Application No.: 10/590,471
Amendment Dated: March 5, 2010
Reply to Office Action of: January 5, 2010

MAT-8885US

Amendments to the Drawings:

FIG. 1

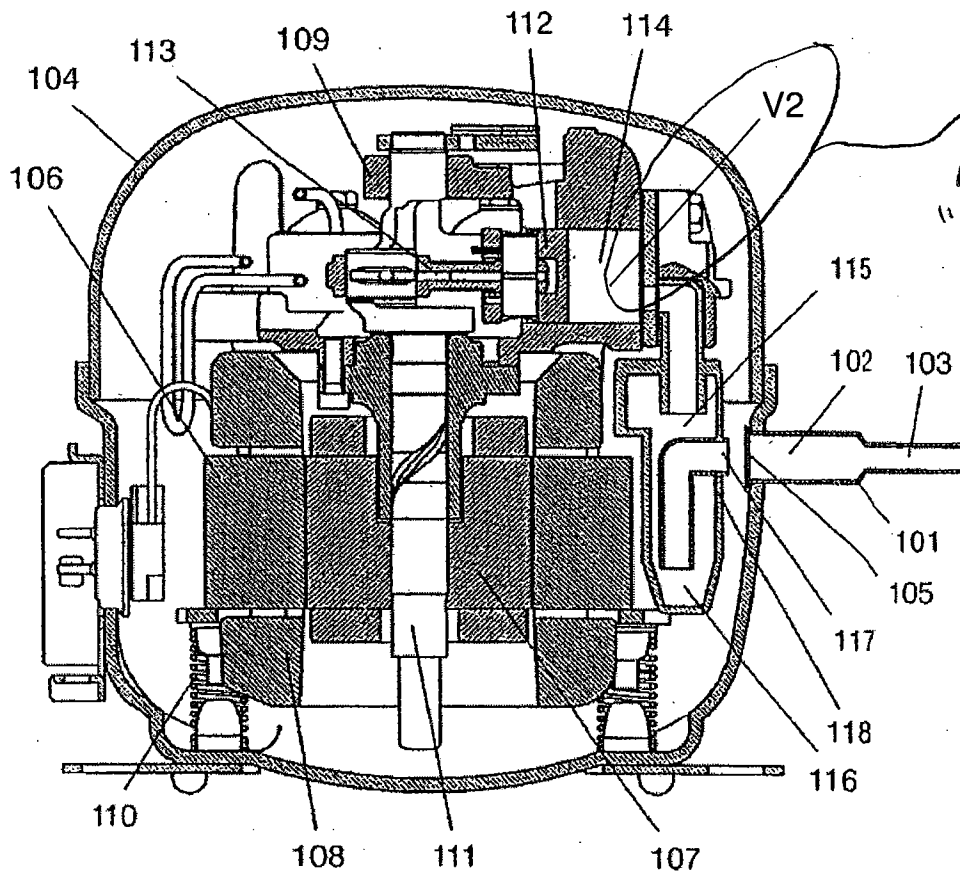
The attached replacement sheet of drawings includes changes to Figure 1. This sheet replaces the original sheet.

The attached annotated replacement sheet indicates the changes made to Figure 1.

Page 2 of the Office Action sets forth "[t]he drawings are objected to...because they do not include the following reference sign(s) mentioned in the description: V2." Additionally, page 3 of the Office Action sets forth "[t]he disclosure is objected to because...[t]he specification contains reference numeral V2, not found in the drawings, as detailed above." Applicants note that the replacement sheet provided with the previous response was included in error. Applicants herewith provide the correct replacement sheet for FIG. 1, which includes the reference sign "V2".

The Office Action further sets forth that "applicant is required to submit a marked-up copy of each Replacement Sheet including annotations indicating the changes made to the previous version." Applicants herewith provide an annotated replacement sheet for FIG. 1. The annotated sheet indicates that a new reference sign "V2" has been added to FIG. 1, along with an associated lead line. The new reference sign and lead line are circled on the annotated sheet. No other changes are made to FIG. 1.
